Representation on the Sheffield Plan Publication (Pre-Submission) Draft

Sheaf and Porter Rivers Trust

Policy BG1: Blue & Green Infrastructure

This is a response by the Sheaf and Porter Rivers Trust (SPRT) to the draft Sheffield Plan policy documents dated December 2022.

Site LR06

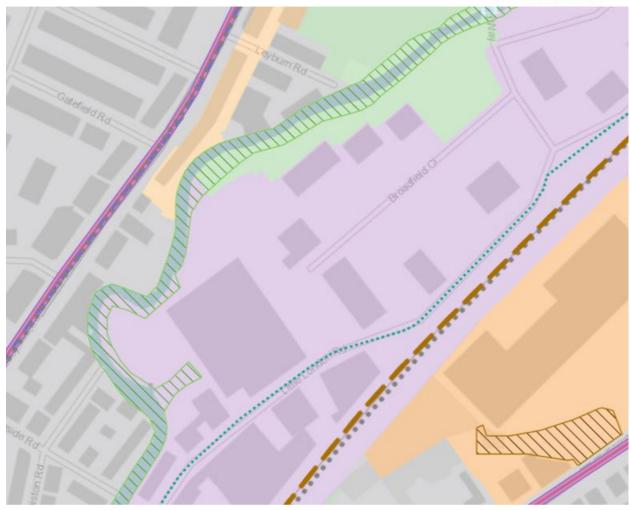
Unsound

As referenced elsewhere, the lack of publication of the Local Nature Recovery Strategy and combined natural capital opportunity maps makes this statement worthless.
